DEVELOPMENT REVIEW BOARD REPORT

| CASE NUMBER/ PROJECT NAME | 36-DR-2005 Office Building For Vanguard Appraisal | | |
| REQUEST | Request approval of a site plan and elevations for a new 2700 sq. foot office building. | | |

Stipulations for Case: Office Building For Vanguard Appraisal Case 36-DR-2005

PRELIMINARY NOT FOR CONSTRUCTION
Site Plan

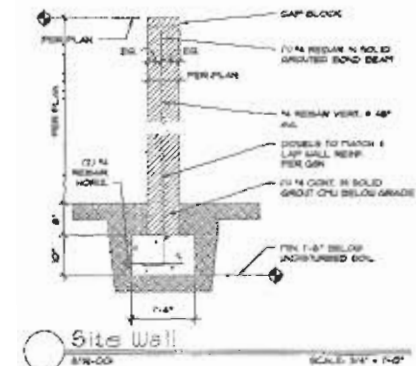
- The design is a modern architectural style.
- The project is subject to McCormick Ranch POA approval.
- Land assembly is required for the property to combine Lots 33 and 34.
- The applicant has been requested to verify that the dumpster location is acceptable to Solid Waste staff or provide for relocation in conformance with City requirements. If relocation is required minor modification of the parking lot may be required, as provided in Stipulation #10.
- No public comment has been received on this case.

10. If City staff requires relocation of the refuse container, the applicant shall make modifications to the parking lot to accommodate relocation of the refuse container, which shall be subject to staff approval.

48. One single refuse enclosure is required for this site. Refuse enclosures shall be constructed to City of Scottsdale's standards. Details for construction of trash enclosures can be found in the City of Scottsdale Supplements to MAG Standards, standard detail #2146-1 for single enclosures.
49. The location of refuse enclosure shown on the Site Plan and Conceptual Grading Plan is not acceptable. Final plan shall show a relocation of the refuse enclosure to east side of site along north-south driveway, angled to provide northbound pickup.

Sheet Number
LA.02

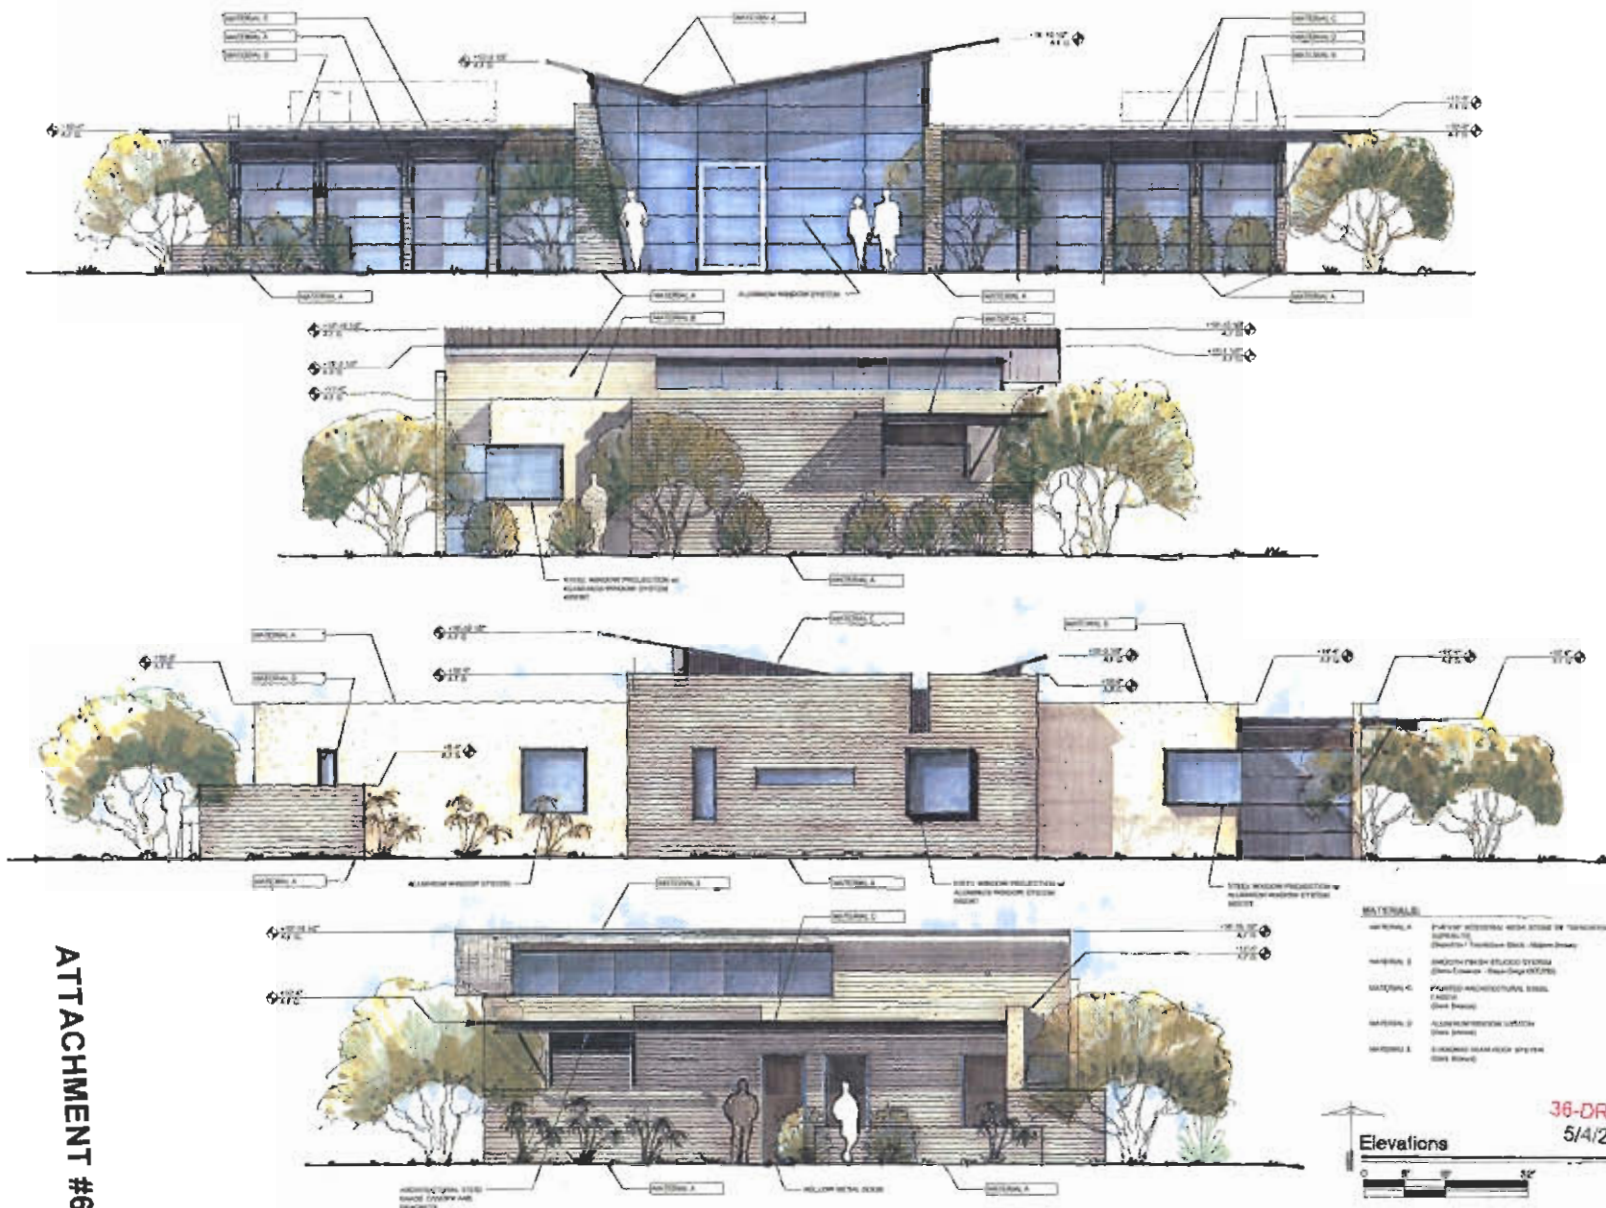
15. Landscape plan shall be revised prior to final plans to indicate all plants that are not listed on the Phoenix AMA plant list and are included in the Landscape data sheet L.O by location on site.
16. Refuse enclosure shall be clear of any proposed mature tree canopies.
17. Upon removal of the salvageable native plants the salvage contractor shall submit completed Native Plant Tracking Form as well as a list identifying the tag numbers of the plants surviving salvage operations to the City's Inspection Services Unit within 3 months from the beginning of salvage operations and/or prior to the issuance of the Certificate of Occupancy.
18. Cut and fill slopes shall be rounded to blend with the existing contours of the adjacent natural grades.

- C. Prior to final plans submittal the Landscape plan shall be revised to include caliper sizes.
- D. 50% of the trees provided shall be mature trees with a minimum caliper size of 2 (two) inches for a single trunk and/or 1 (one) inch average for multi-trunk trees or equivalent.
- E. With the relocation of the refuse container the site shall meet all required parking lot landscape requirements of the zoning ordinance.
